① National Dam Inspection Program
GLADE RUN DAM.
(NDI Number PA 01071)
(PENN DER Number 10-60)
PENNSYLVANIA FISH COMMISSION.

PHASE I INSPECTION REPORT.
NATIONAL DAM INSPECTION PROGRAM

GLADE RUN DAM
BUTLER COUNTY, COMMONWEALTH OF PENNSYLVANIA
NDI NO. PA 1071
PennDER NO. 10-60

PHASE I INSPECTION REPORT
NATIONAL DAM INSPECTION PROGRAM

DATE: MARCH 1981	GLADE RUN DAM
SCALE: NONE	NATIONAL DAM INSPECTION PROGRAM
DR: JF CK: JEB	ACKENHEIL & ASSOCIATES CONSULTING ENGINEERS
DWG. NO. 80138P-1	1000 PANKSVILLE RD. PITTSBURGH, PA. 15216

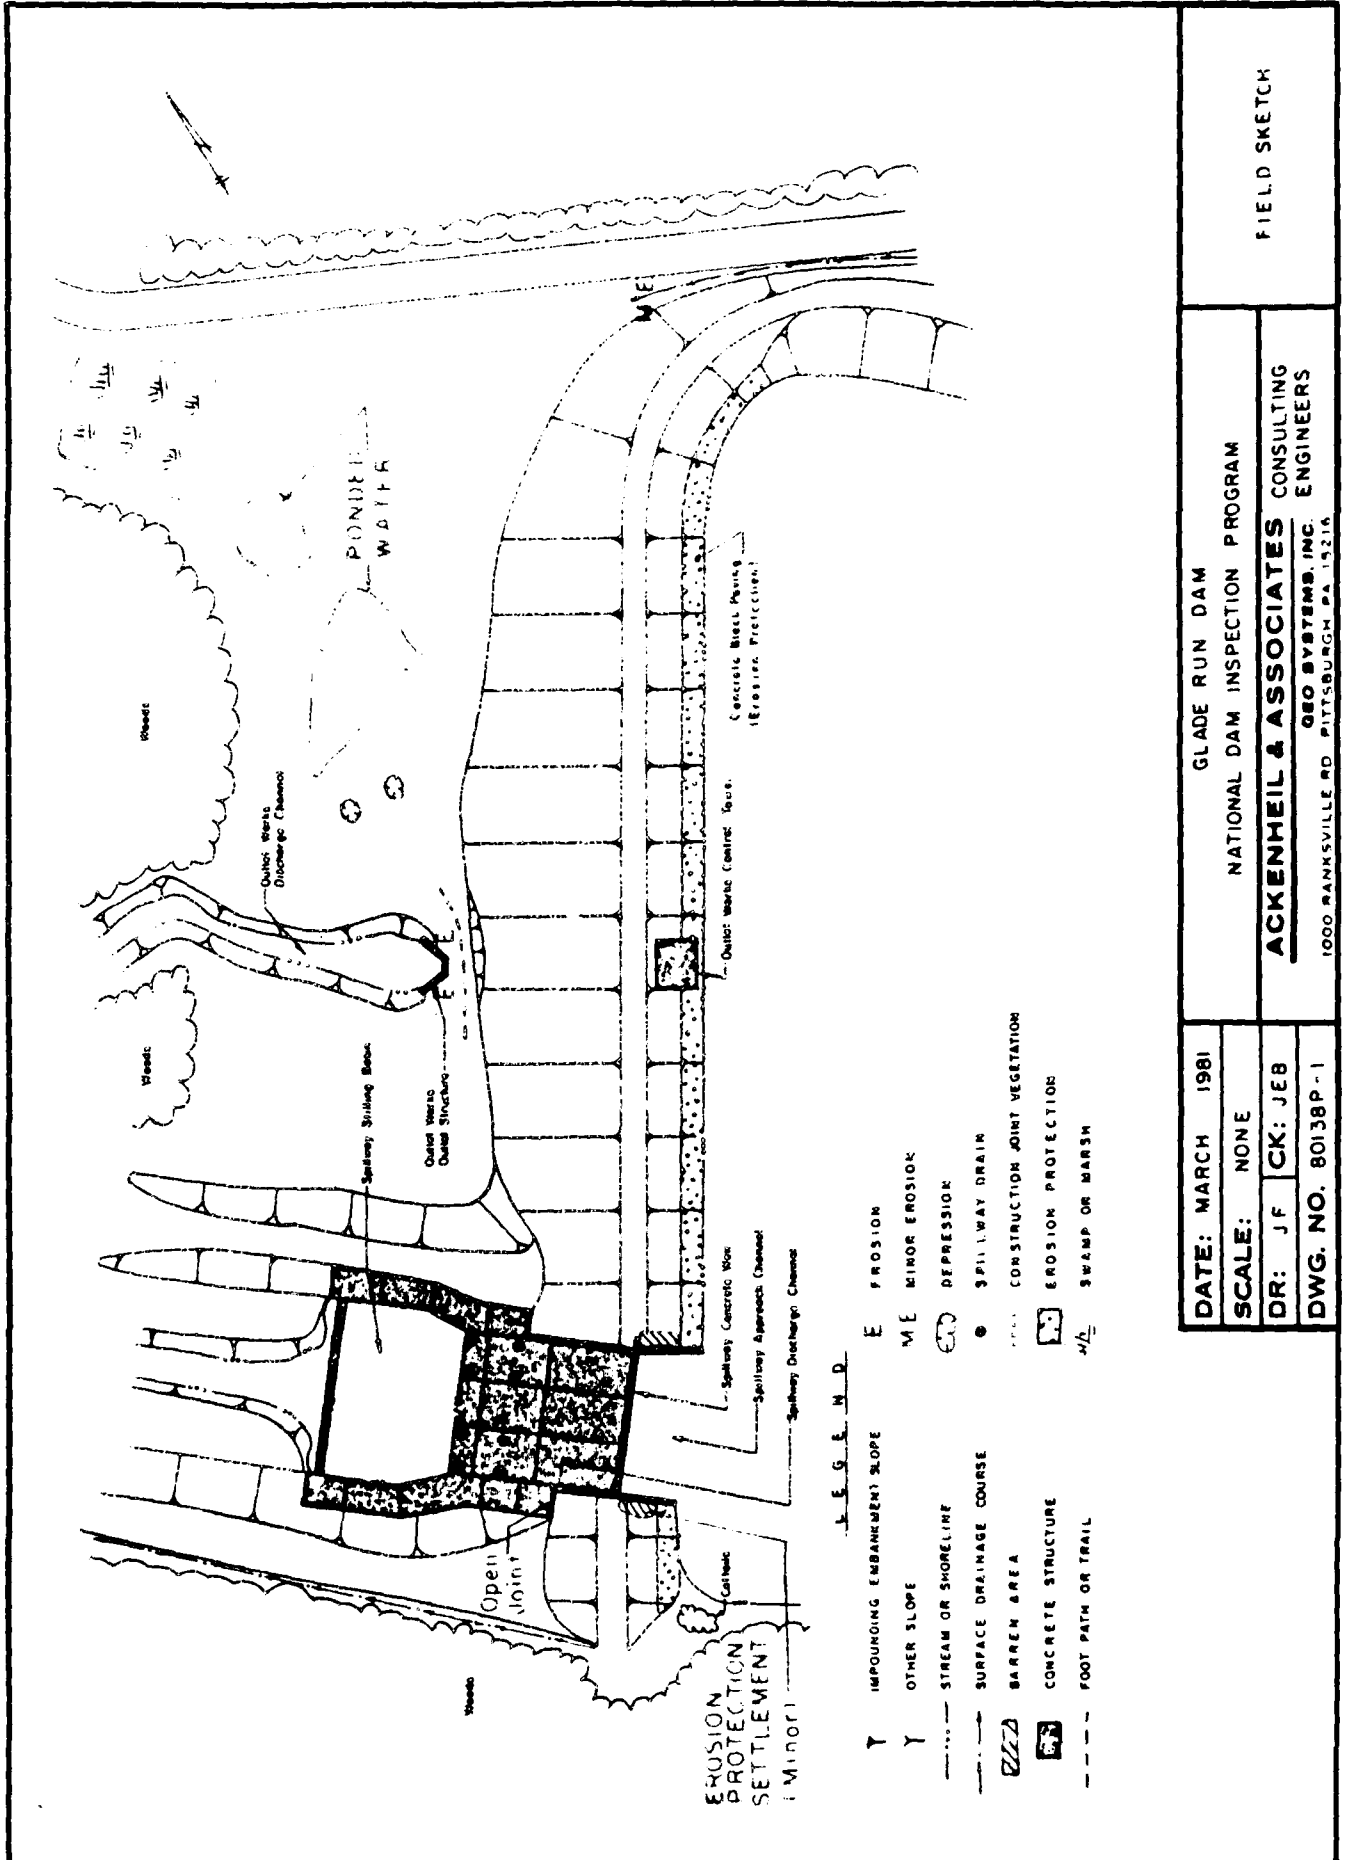
Minor settlement of the erosion protection was noted immediately to the left of the spillway's left training wall.

EROSION PROTECTION SETTLEMENT (MINOR)

c. Repair of the minor settlement in the concrete block pavement near the left spillway training wall.
